Re: (Final) Notice of Product Discontinuation

Table 2.1 Discontinued Models and Recommended Replacement Models

Figure 2.1 Differences of Dimensions between BRFS50, BRFS50L and BRFS60

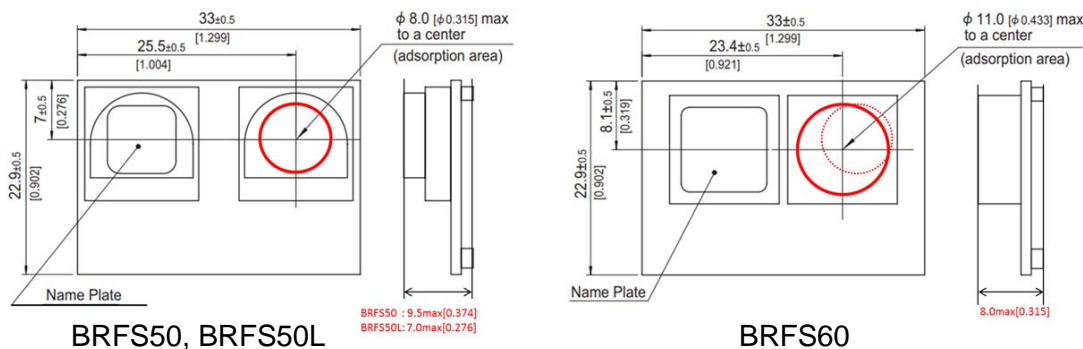
There are some changes. In details, please see Fig 2.1.

The product height and the diameter of adsorption area are different.

But the pin assignment and footprint are the same and this change does not impact the electronic specifications and the product reliability and safety approvals.
